**Daniel Building Renovation for:
Midwestern State University
Wichita Falls, Texas**

BYSP PROJECT NO. 18071

September 24, 2020

TO: All Contract Bidders of Record

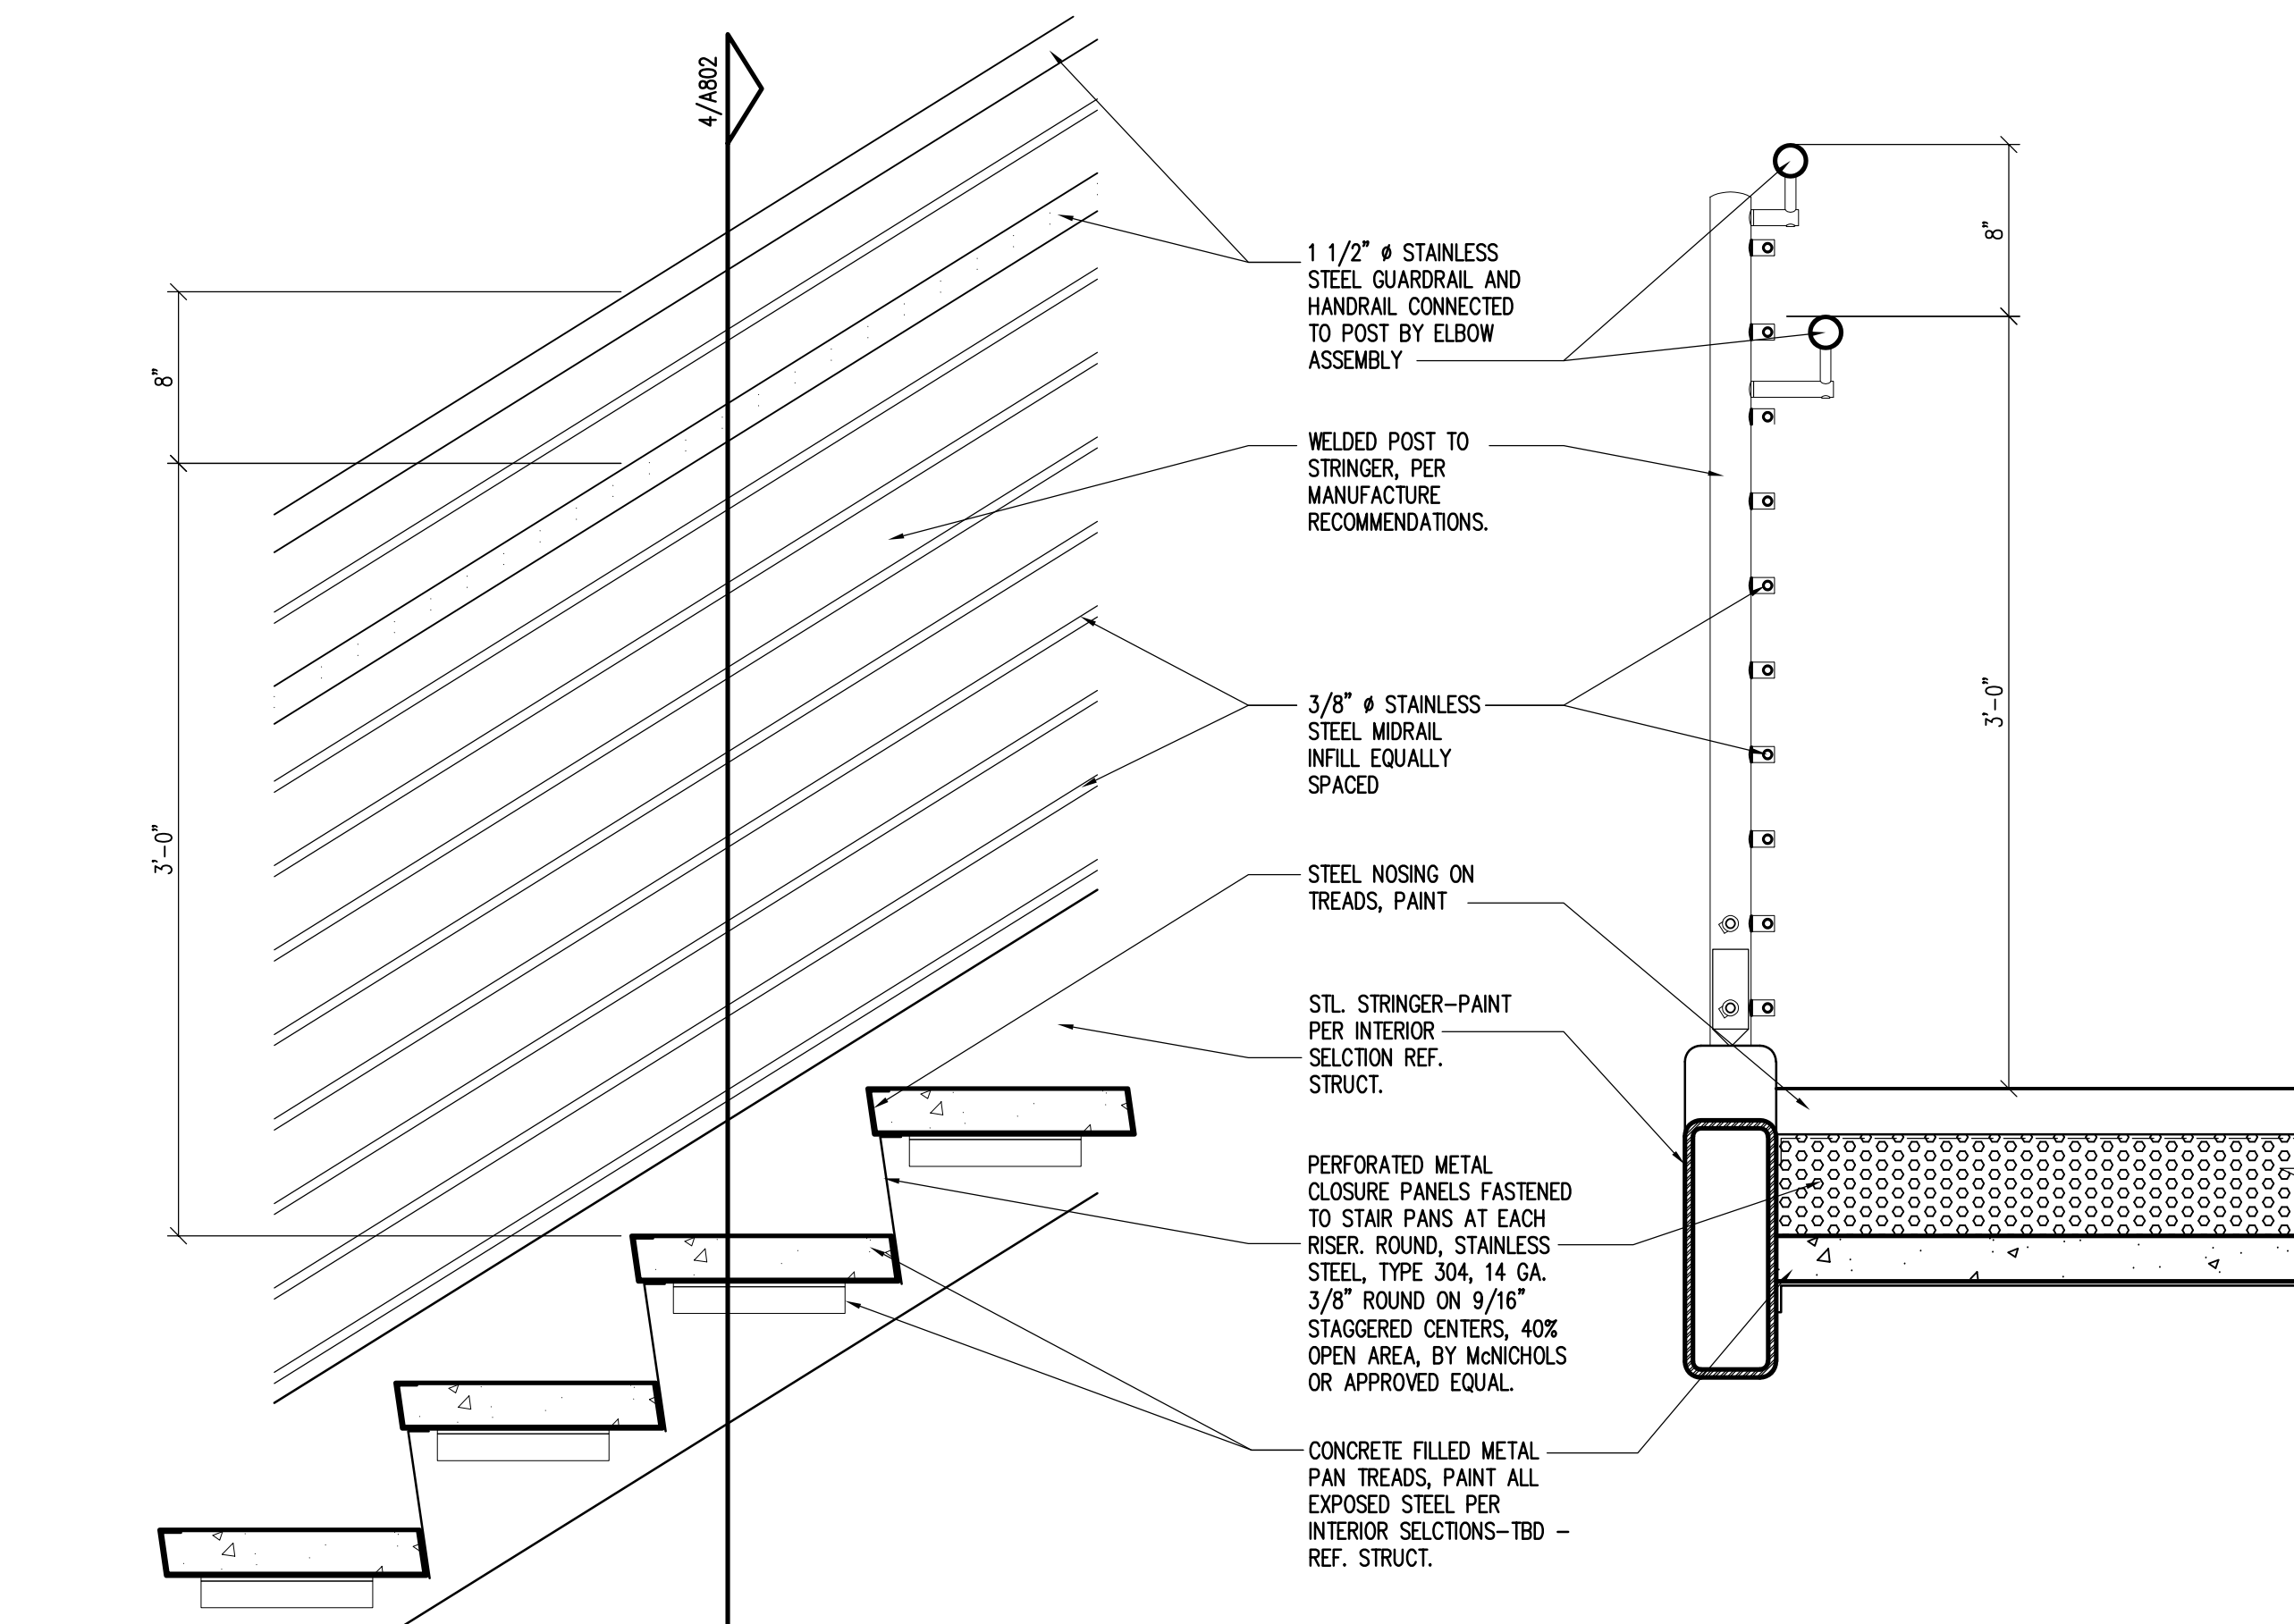
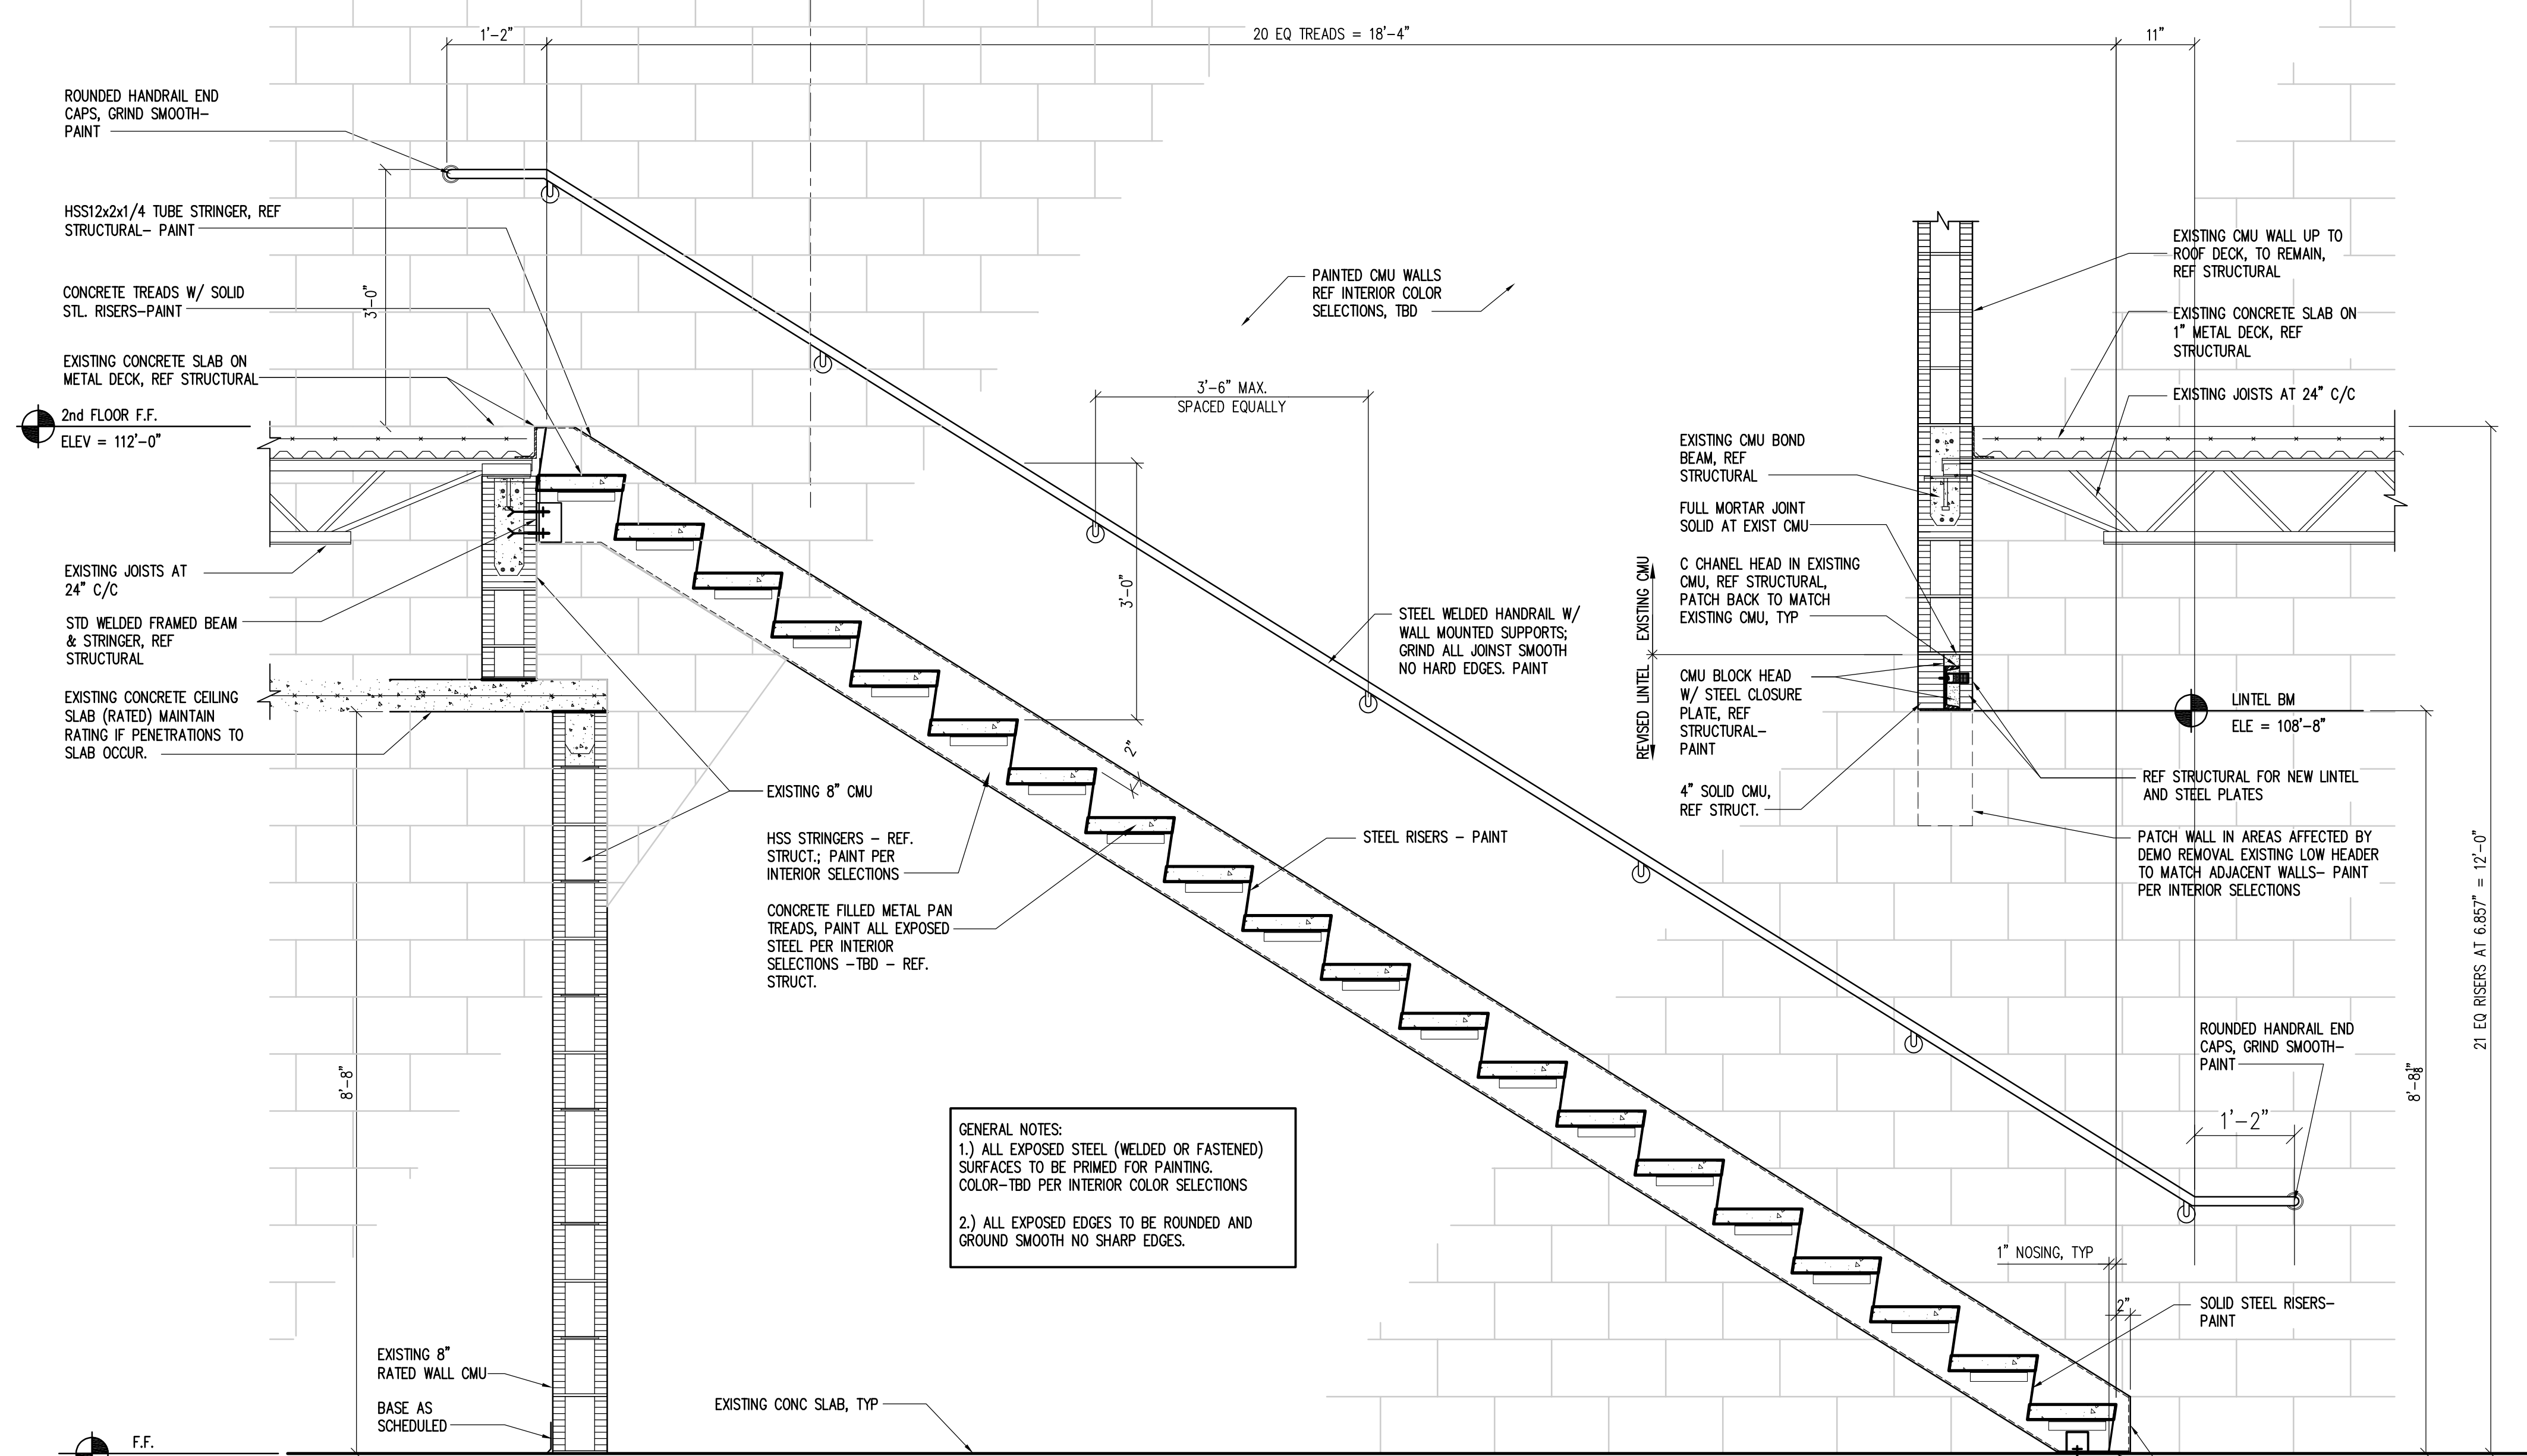
- Additional step(s) at front entry area per changes in grading on civil drawings.
- Concrete ramp at East entry per revised civil

- Added Detail 16 - Concrete Bollard
- Added Detail 10 - Two Step Handrail
- Added Detail 17 - Wood Fence

6. Keynote #7 on Sheet SP102 references Detail 16/SP201. Sheet SP201 does not have a detail 16.

51. Drawing SP101 Site Key Notes: Keynote 7 references detail 16 on Sheet SP201. Please note that SP201 does not have a Detail 16. Please provide Detail 16 for the 16in diameter concrete bollards.

Response: Detail for decorative bollard included in Addendum #3

Response: Detail 16 is included with Addendum #2
